STAFF EVALUATION: Staff has the following concerns and comments regarding this project:

TENTATIVE MAP
SMOKETREE CONDOMINIUMS
CITY OF SACRAMENTO, CALIFORNIA
MARCH 1980

SMOKETREE CONDOMINIUMS
SACRAMENTO, CALIFORNIA

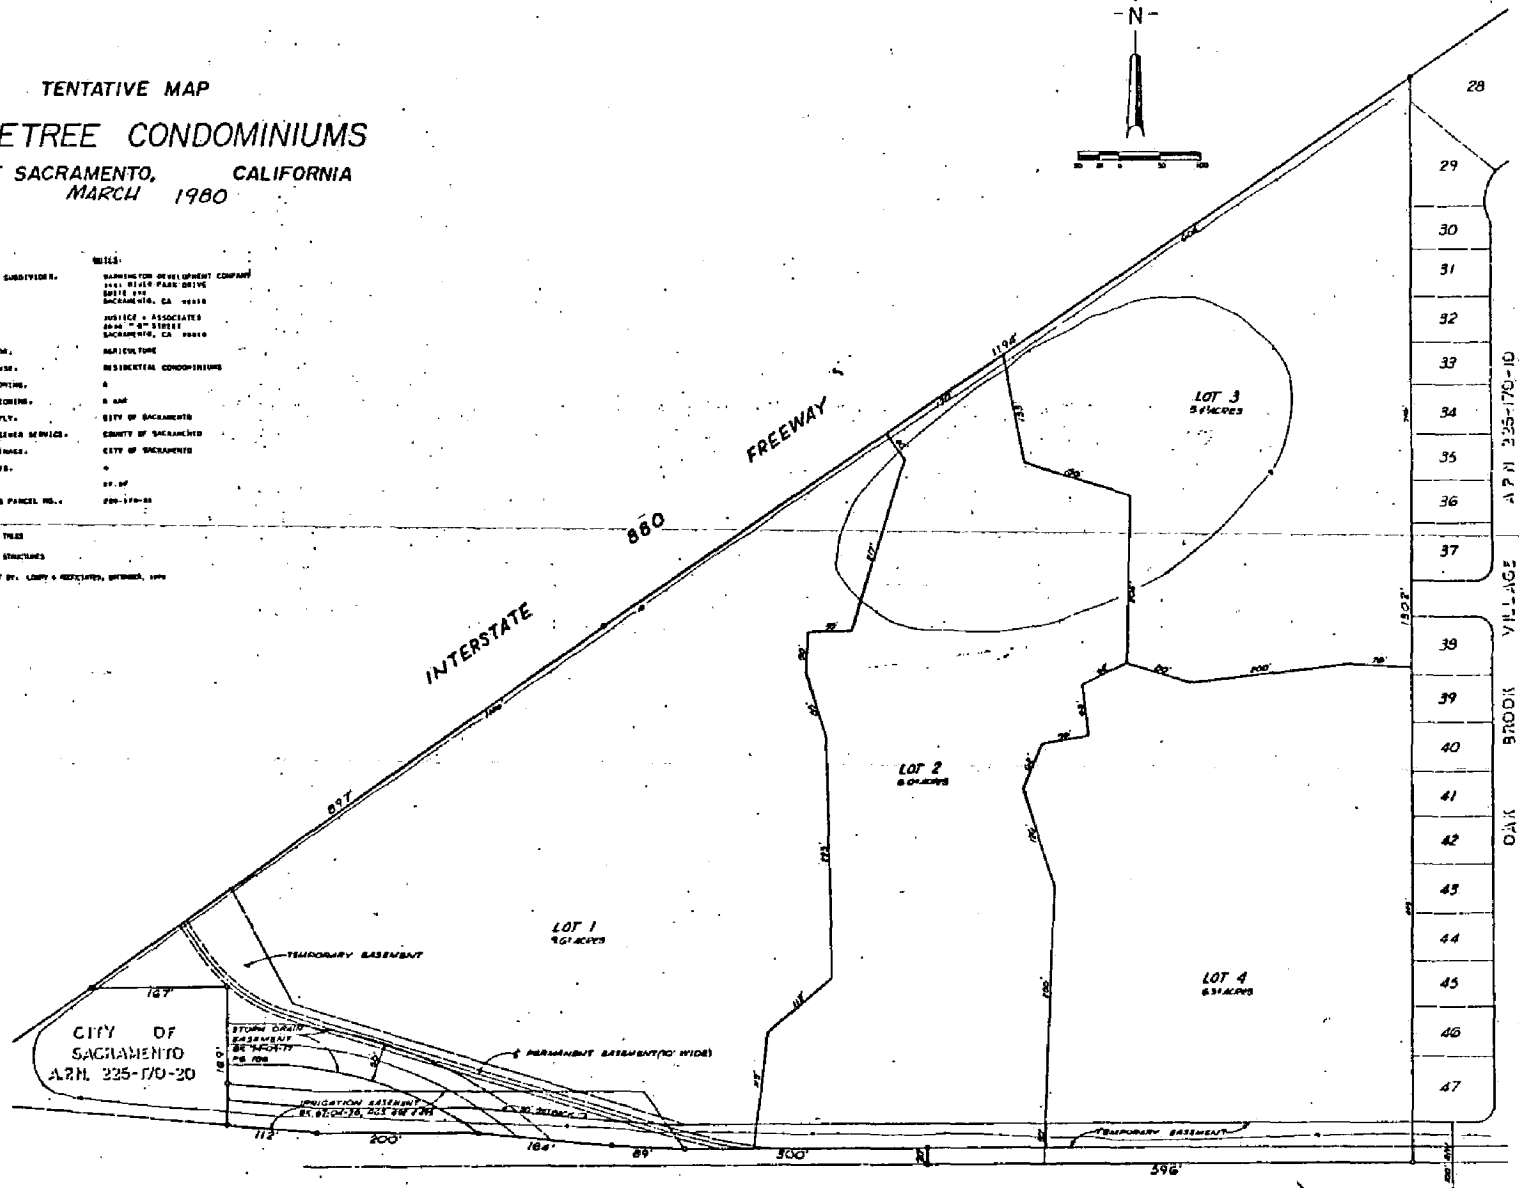
2. Parcel 3 of the tentative parcel map is a land-locked parcel. This type of parcel should be avoided because if this phase of the project is not developed and the property is sold to another individual, there may be problems with access to the site. Staff suggests that Parcel 3 be redesigned to allow access from San Juan Road.
3. The adjacent property to the east was recently approved for single family development and a stub street was provided to the subject site. The applicant's site design does not show any access to the stub street. Staff suggests that the stub street be deleted from the approved subdivision on the east. This would require the developer on the east to submit a request to change the lot design on the approved tentative map.

- g. Applicant shall redesign the parcel map to provide frontage on San Juan Road for Parcel 3.

CONCEPTUAL LANDSCAPE
PLANTING PLAN

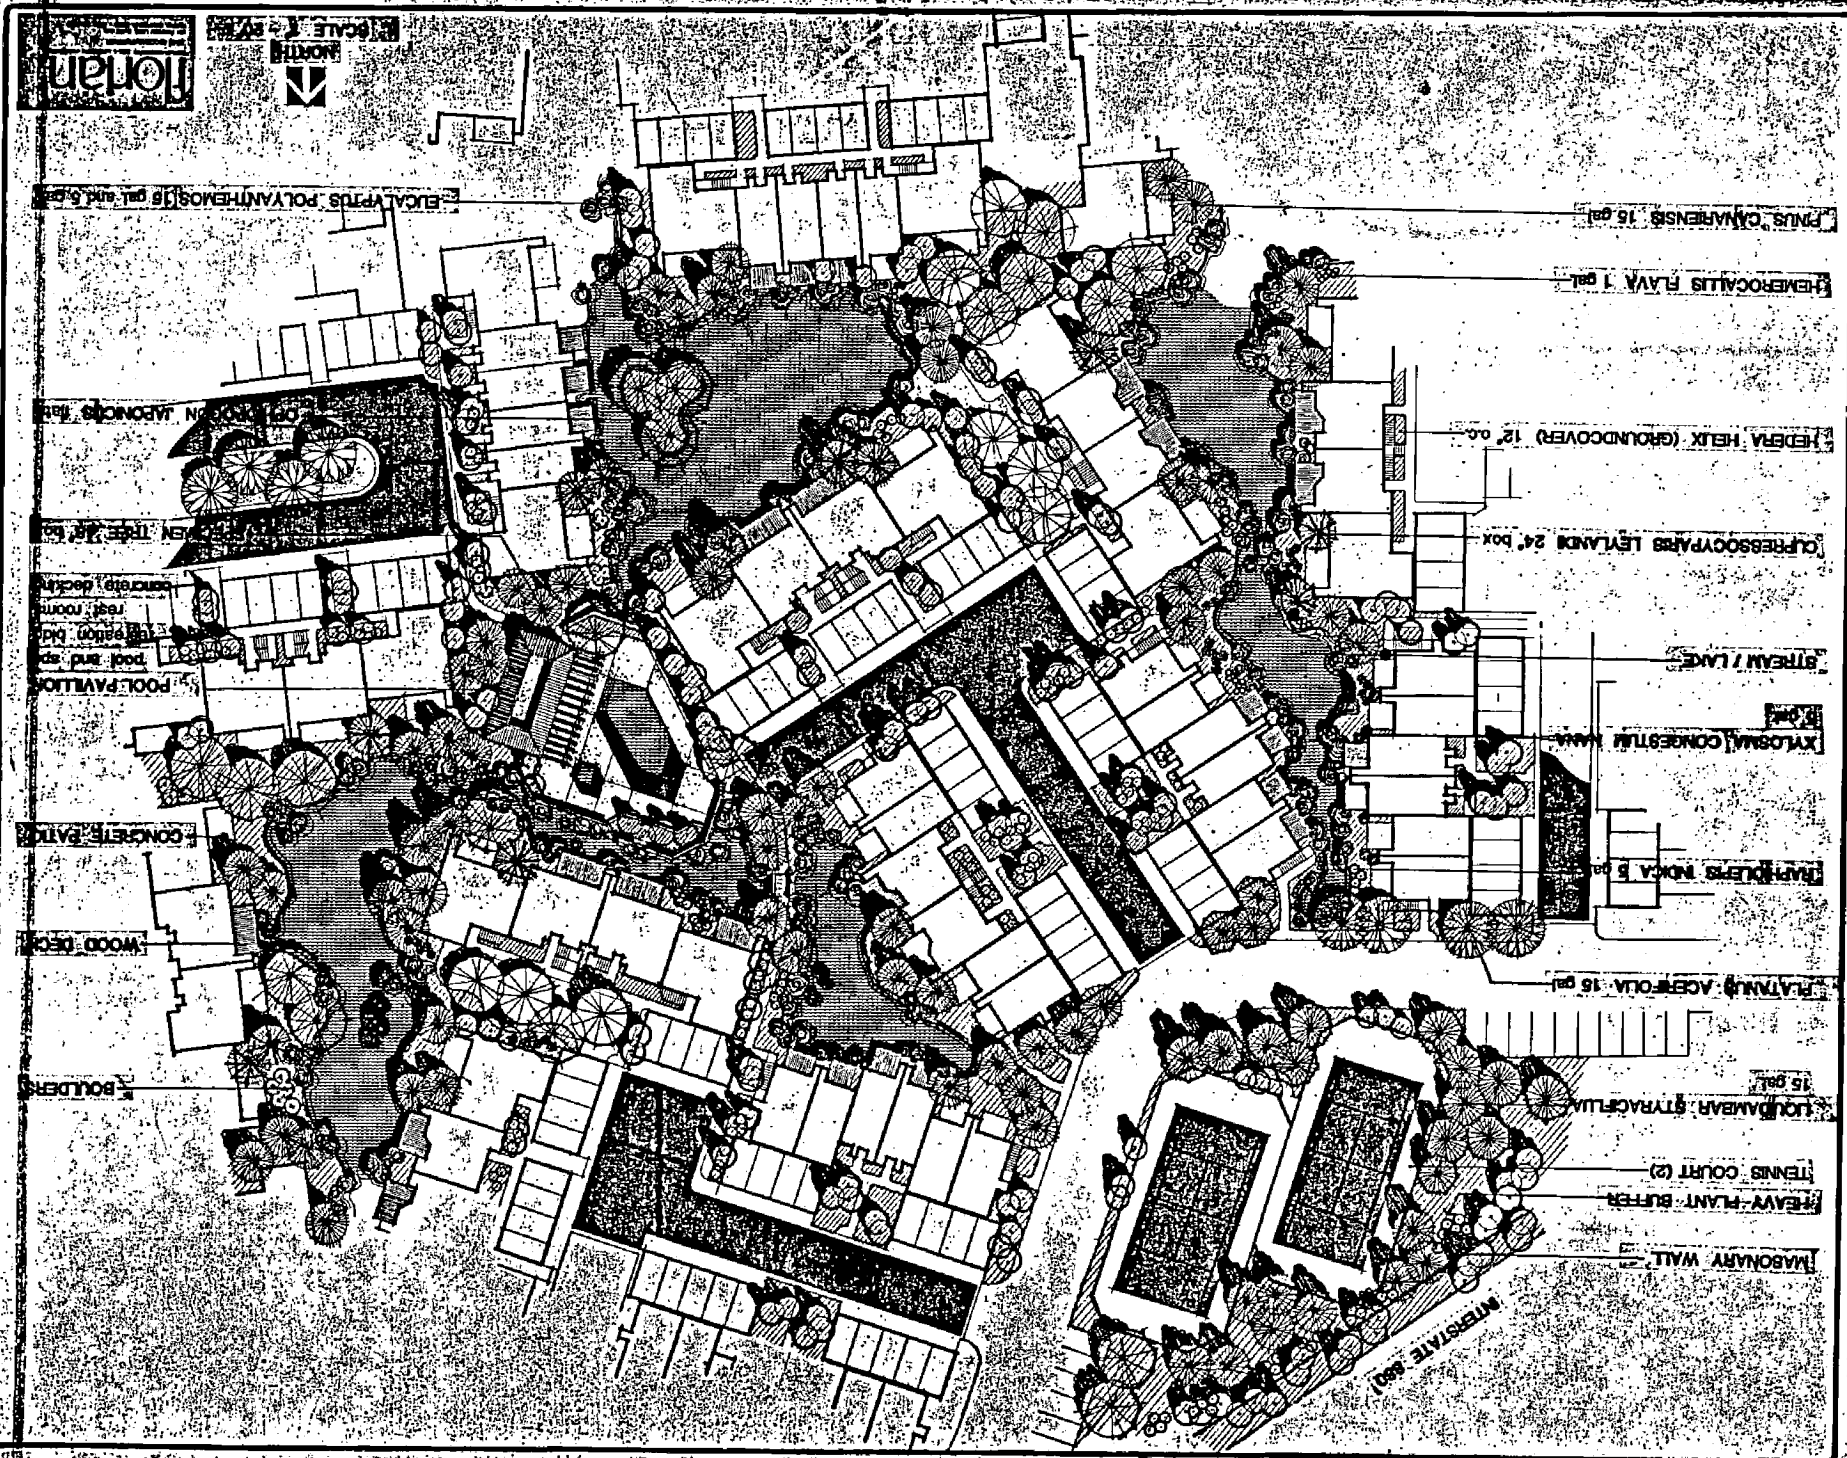
1. The site plan indicates an extensive amount of lakes and waterways throughout the project. However, the applicant has not indicated the depth of the waterways; whether or not they will be lined; if lined, with what material; whether or not the waterways will be circulating or filtered; and the water source. The Subdivision Review Committee members also expressed a concern regarding the maintenance and potential health problems associated with the proposed bodies of water.

As early as November, 1979, when this project was first submitted to staff for preliminary review, staff expressed concern over the size and maintenance aspects of the proposed waterways. At that time the applicant proposed smaller bodies of water than is now indicated on the site plan. The applicant has not yet submitted any studies which address the maintenance or health aspects of this proposal. Because of insufficient information, staff cannot support the usage of the waterways.

5. Staff requests that the applicant submit a detailed irrigation and landscape plan subject to staff review and approval prior to the issuance of building permits. The plans shall adhere to the following guidelines:

6. The site plan indicates a parking area at the northeast corner of the subject site. Due to the adjacent single family zoned property, staff suggests that this parking area be eliminated. In addition, staff requests that all parallel parking spaces be eliminated to provide for adequate vehicle circulation.

7. The applicant proposes to utilize a combination of a wall and berming for sound attenuation along I-880. Staff has no objection to this concept providing the berms are landscaped and the wall is constructed of a masonry type material. Also, the wall should be constructed prior to recordation of the first phase (Parcel 1).

- a. The lakes and waterway elements throughout the project shall be eliminated; (CPC amended to...shall not depend on City water-shall use well water.)

- d. The two pools indicated on the site plan shall be heated by solar energy only;
- e. The applicant shall submit a detailed landscaping and irrigation plan for review and approval of the planning staff prior to the issuance of a building permit. The applicant shall make every effort to employ the use of deciduous trees as a passive solar technique. The plans shall include elements that are indicated on No. 5 of staff evaluation;

- f. The applicant shall eliminate the proposed parking area in the northeast corner of the subject site and all parallel parking within the site.
